BIDDERS BULLETIN

PROJECT: Gateway Realty of North Platte
North Platte, Nebraska

BB-1

DATE ISSUED: February 7, 2014

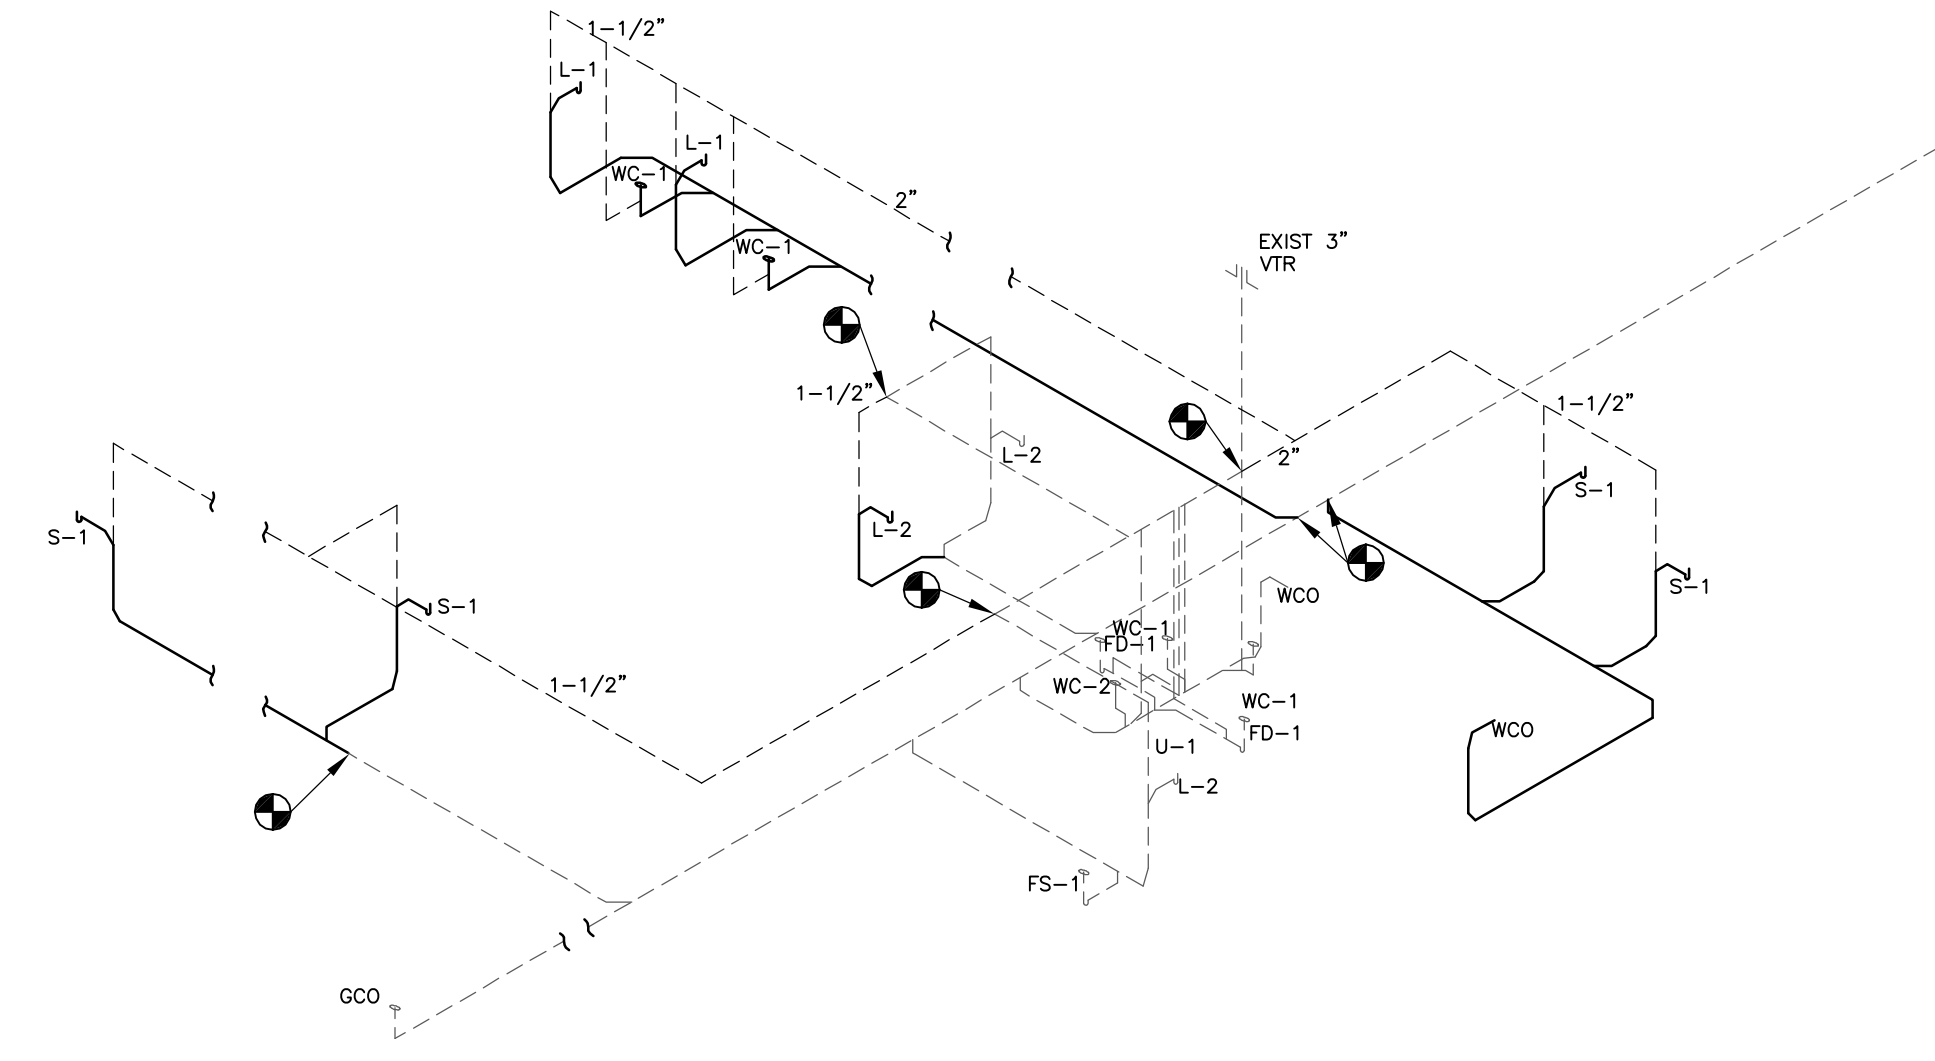
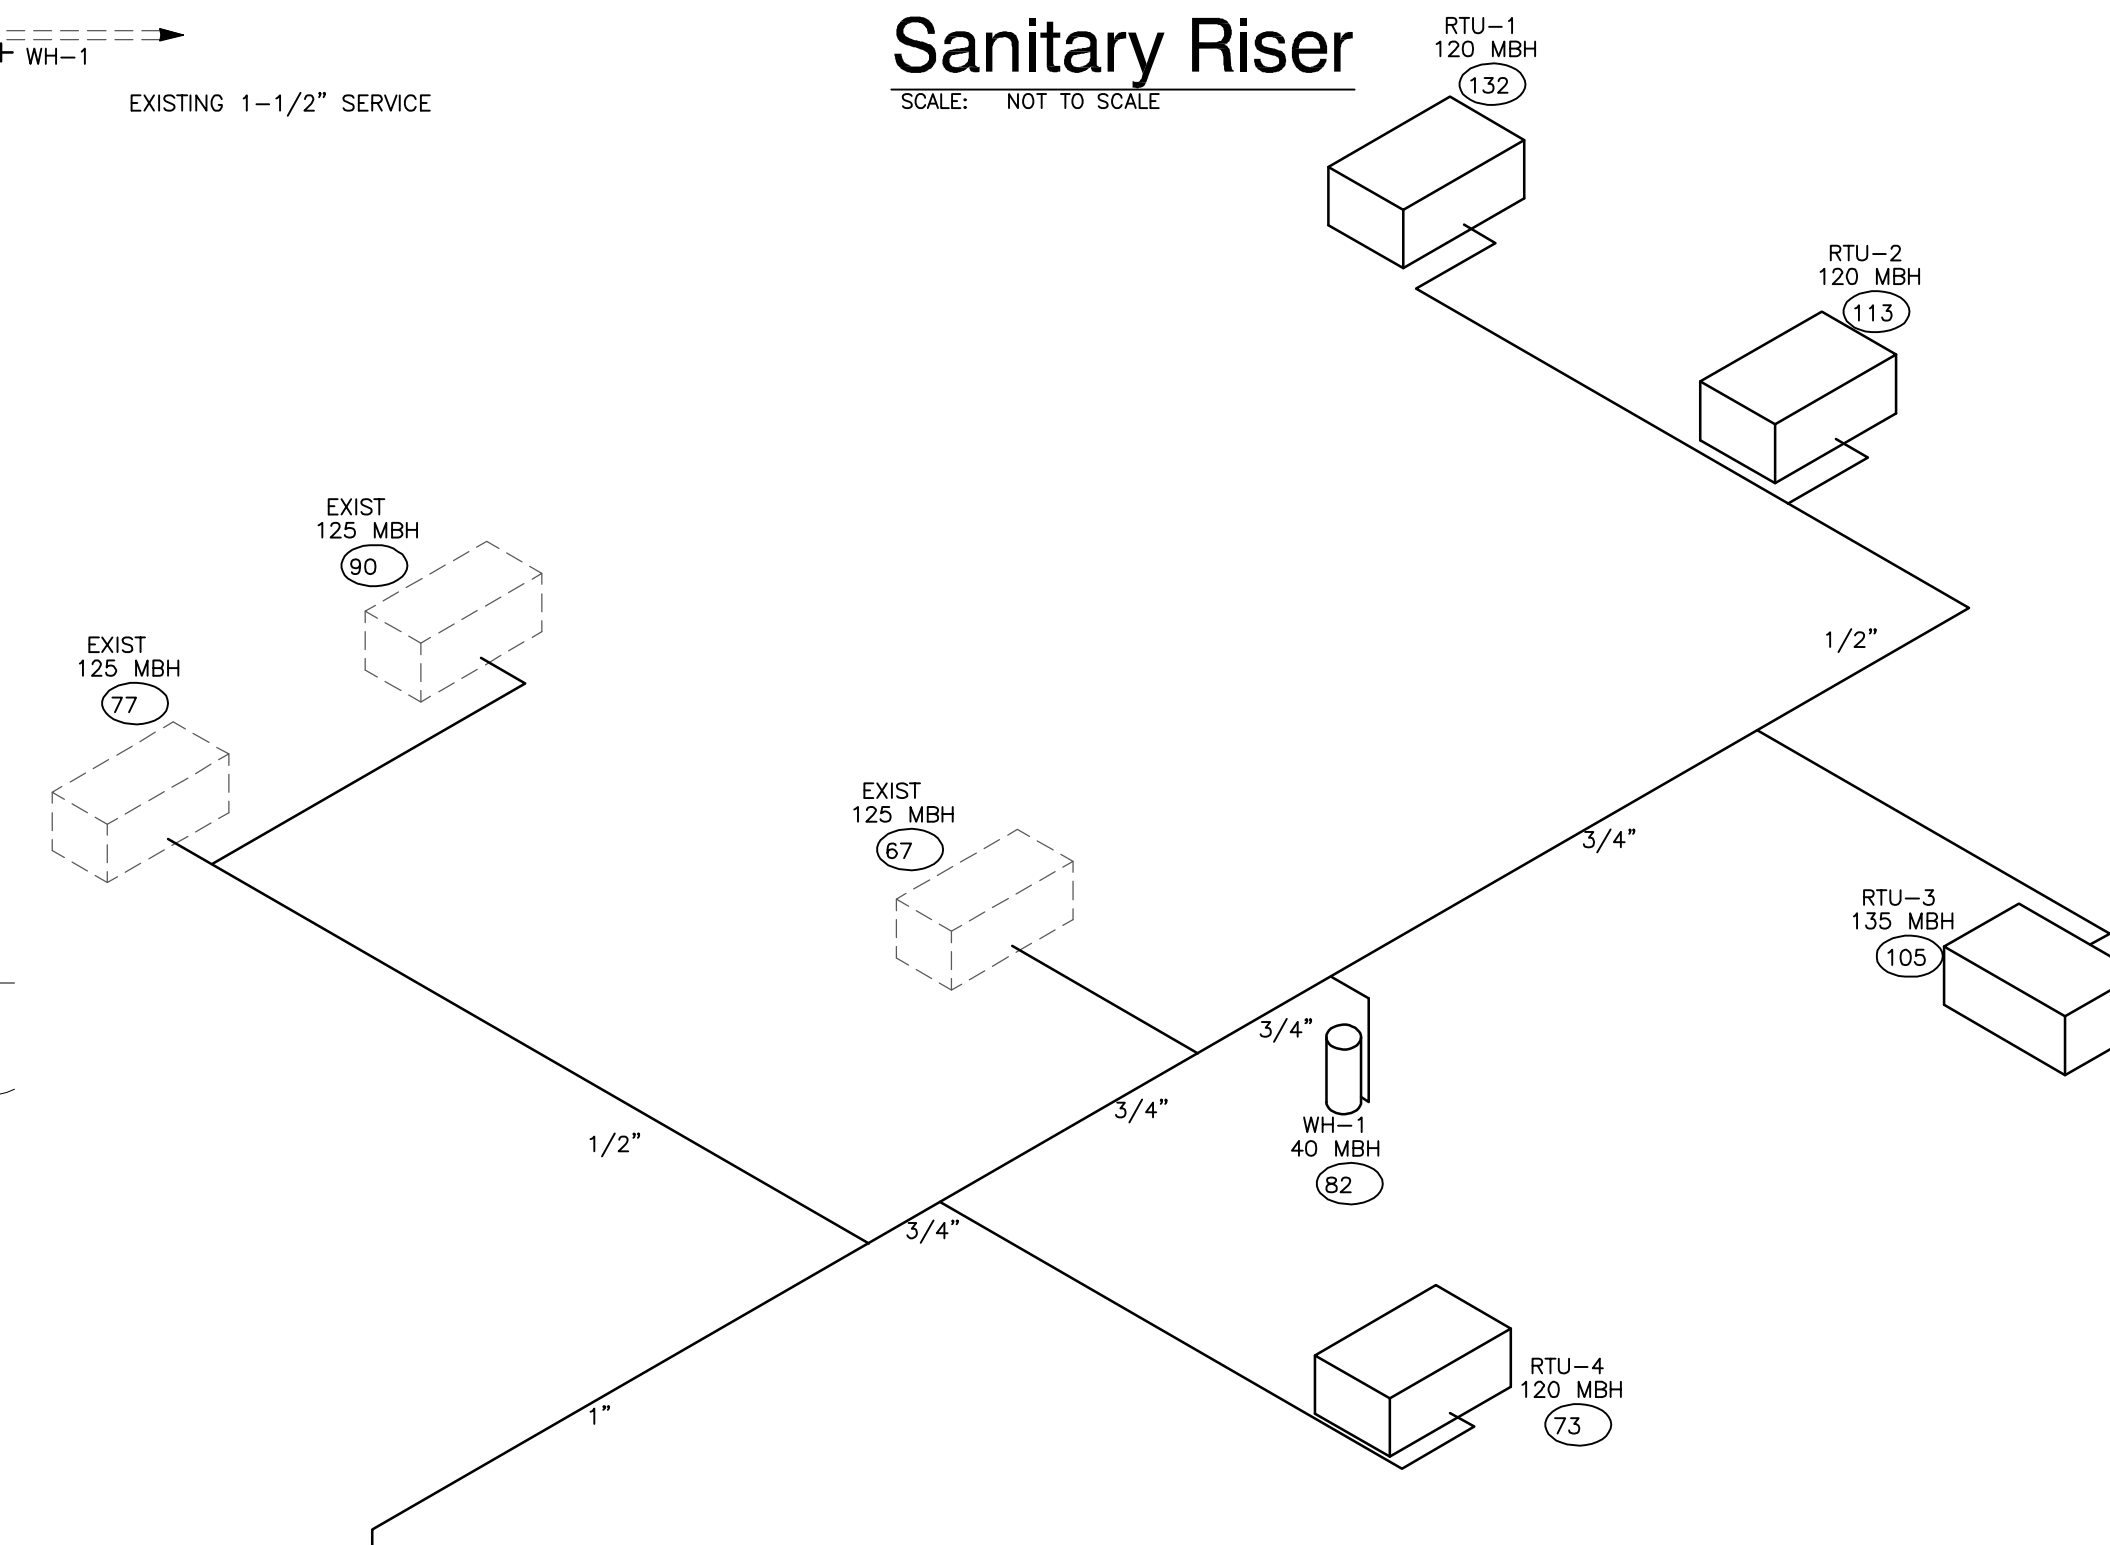
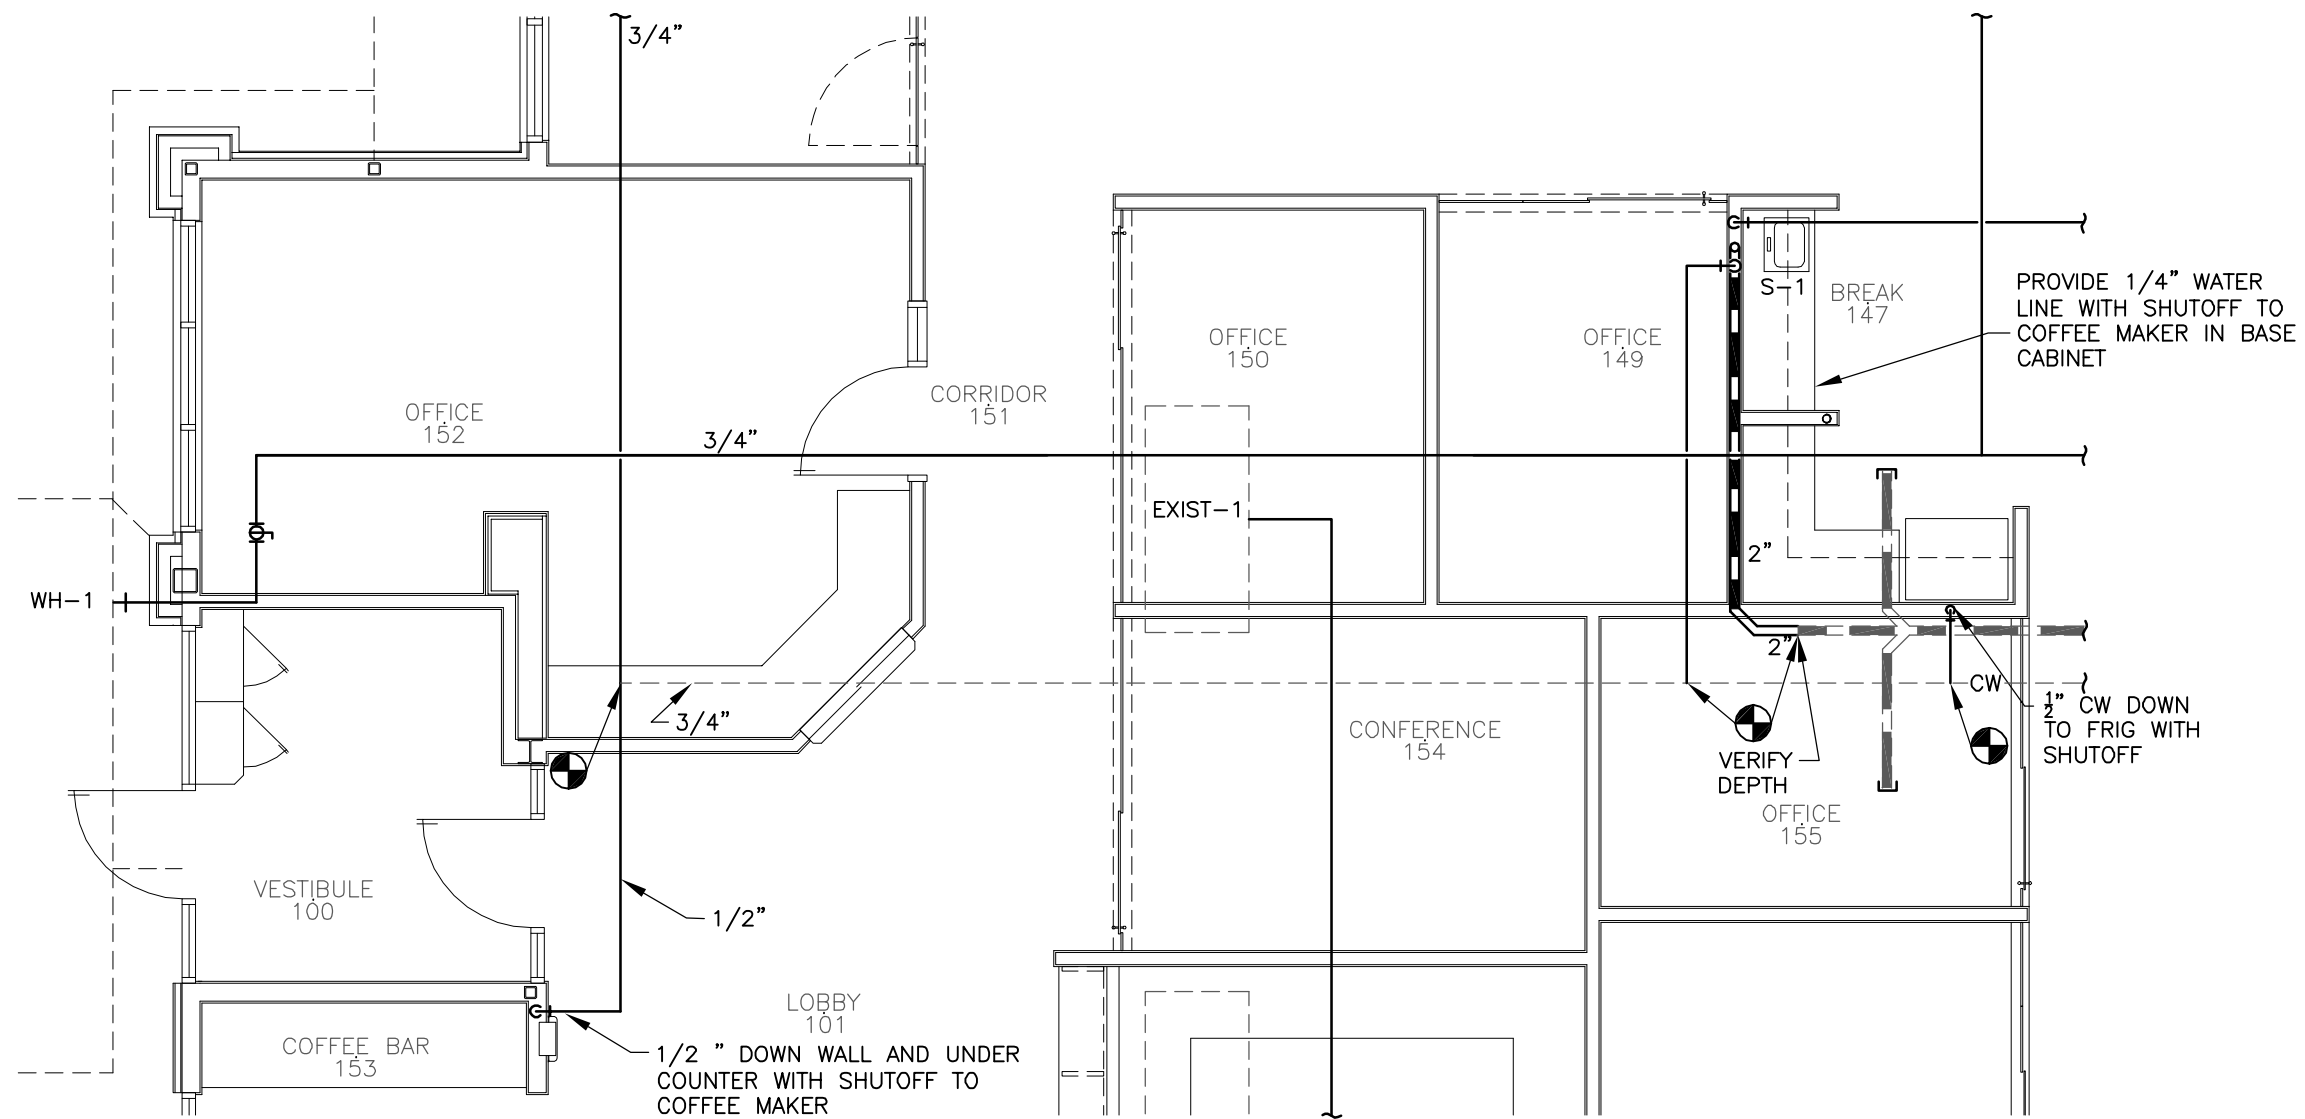
- Revised roof drain layout
- Add un-softened cold water to hose bibs
- Reconnect un-softened cold water to existing landscaping piping
- Refer to sheet P101.1 Plumbing Plan
 - Plumbing plan modified to accommodate revised floor plan
 - Remove sink as well as associated hot water and waste in coffee bar area install ½" cold water with shutoff for coffee maker
 - Add ¼" water line with shutoff from sink to coffee maker in base cabinets of break room 147

Gateway Realty North Platte, NE	GEARY ENGINEERING, INC.
Power Plan and Lighting Schedule	
SHEET: E-1R (Pre-Bid Add. #1)	7800 'O' STREET SUITE 100 Lincoln, Nebraska 68510 Tel. (402)489-7627 Fax (402)489-7630 Project # 23043
DATE: 01-30-14	
DRAWN BY: CAH	
CHECKED BY: RWG

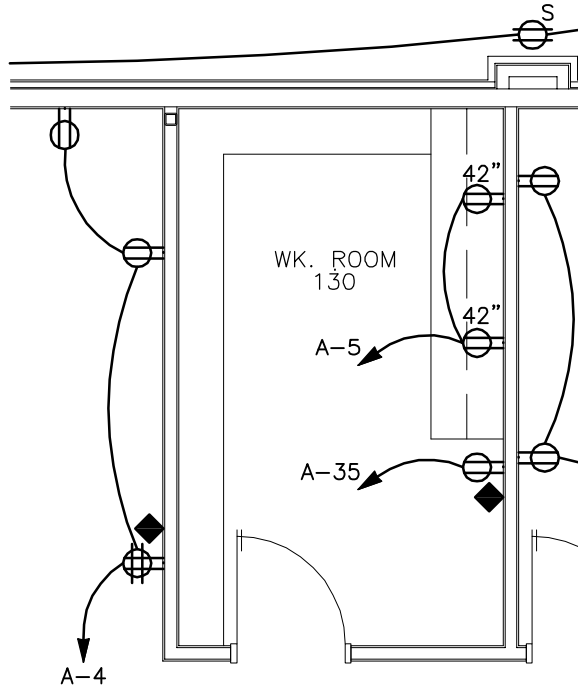
- Type #17 in the light fixture schedule is now specified. Please see attached drawing E-1R for more information.
- Refer to sheet E101.1 Revised Lighting Plan
 - Lighting plan modified to accommodate revised floor plan
 - Undercounter lights have been removed from Coffee Bar area.
 - Relocated switch serving lobby lighting
 - Emergency light for egress purposes on exterior column is now shown on the north column in lieu of the south due to new exit door location.

- The power layout in Work Room130 has been revised. Adjustable shelving is to be installed on the north and west walls of this room and the electrical has been removed in those areas. Please see new power layout on the attached sheet E-1R for more information.
- It is the responsibility of the Electrical Contractor to supply the (3) electrical hand dryers specified in section 10800.
- Refer to sheet E102.2 Revised Power Plan:
 - Additional receptacle and cable TV outlet have been added to the east wall in Break room 147.
 - Additional receptacle and 2-gang box at 72" A.F.F. per Power Plan Notes 2, 3 & 4. Center 3 & 4 on the north wall of Coffee Bar 153 above the coffee bar. Keep the (2) outlets at 44" A.F.F. as indicated on the original drawing.
